PRELIMINARY DRAINAGE STATEMENT

**MERCADO DEL LAGO
8300 N HAYDEN RD
SCOTTSDALE, ARIZONA 85258**

**Re: Stormwater Review Responses
Mercado Del Lago
8300 N Hayden Rd
Scottsdale, Arizona, 85258
EEM Project: 16-EEM-2354CIV
20-DR-2016**

Comments on Grading and Drainage
Mercado Del Lago
(City of Scottsdale Case Number: 20-DR-2016)

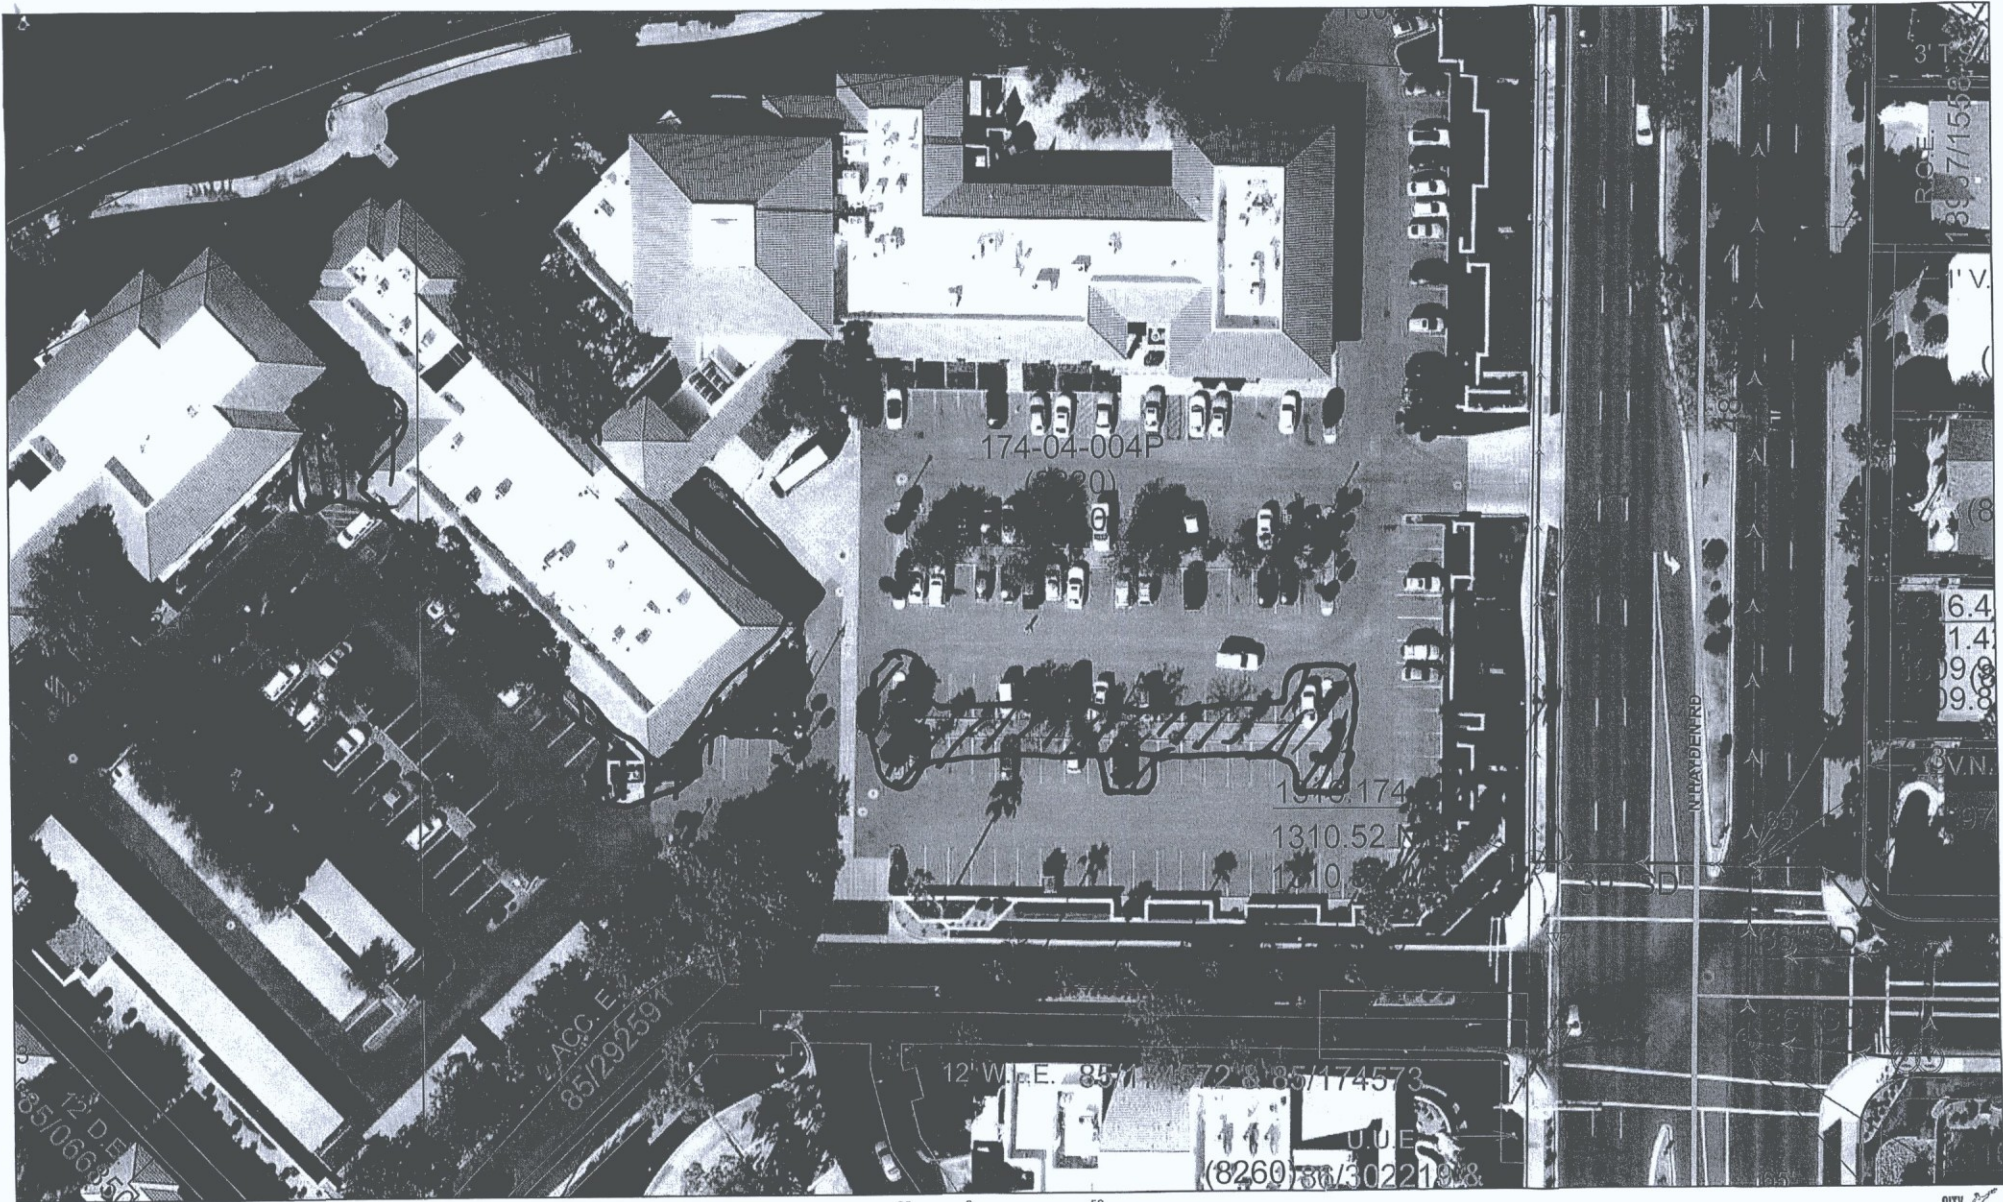
2. As can be seen in the attached 11"X17" color printout from the COS Land Information System (LIS), a noticeable (if not significant) existing landscape area is being proposed to be converted into impervious area by means of a proposed building and additional parking lots. This is not allowed unless an equivalent landscape area is provided onsite or onsite stormwater storage basins are provided to store the increased runoff volume from the 100-year, 2-hour storm event. [*Reference: COS DS&PM: Section 4-1.402 & Section 4-1.800; COS Stormwater Ordinance: Section 37-32(c) & 37-43(b)*]

3. The attached 11"X17" color LIS printout is marked up with red hatch-lines for the Engineer's reference to show the noticeable (if not significant) existing landscape area which is being proposed to be converted into impervious areas. The Engineer must provide an 11"X17" color Pre-development Land Use Map in the drainage report on which all existing landscape areas must be delineated and be quantified (in square feet) on an aerial map. A Runoff Coefficient ('C') value of 0.45 should be used to compute the 'Stormwater Storage Volume' requirement using the $V = CRA$ equation. [*Reference: COS DS&PM: Section 4-1.402 & Section 4-1.900*]

2. As demonstrated in the drainage statement the impervious (hardscape) surfaces and landscape areas of the site will remain relatively the same.
3. A land use map delineating the existing and proposed hardscape and landscape areas is included in the drainage statement.
